United States Patent and Trademark Office

This is a non-final Office Action for application number 10/698,158 Flexible Support Arm, filed on 10/31/03. Claims 1-3, 5-21 are pending. The text of those sections of Title 35, U.S. Code not included in this action can be found in a prior Office action.

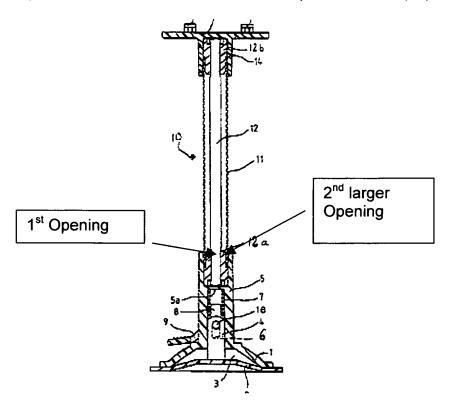
Richter teaches the basic inventive including teaching a flexible support apparatus (10) having a support base (10) having an opening in one surface and a mounting bracket having an opening (13) in one surface and a permanently bendable continuously solid metal rod of substantially constant cross section, the rod being made of aluminum (12, See Col. 3 line 9 for rod material) having a first end installed in the opening of the support base and fused direction to the support base and having a

second end installed in the opening of the mounting means and fused directly to the mounting bracket and wherein the opening in the support base and mounting bracket have a second larger opening (Inner and outer openings, See Drawing Below) into which a flexible sheath (11) if inserted. Richter teaches the method forming a support base, forming a mounting bracket and fusing a length of the rod to the tubular apertures of the base and the bracket, a flexible plastic sheath (11) disposed around the metal rod (12) between the support base and the mounting bracket and wherein the bracket and the base both have a respective counter-bore which is substantially concentric with the respective tubular aperture and sized to admit the flexible plastic sheath (11).

This is unpersuasive because it is evident from the rejection above that the sheath fits into the second larger opening of the mounting bracket.
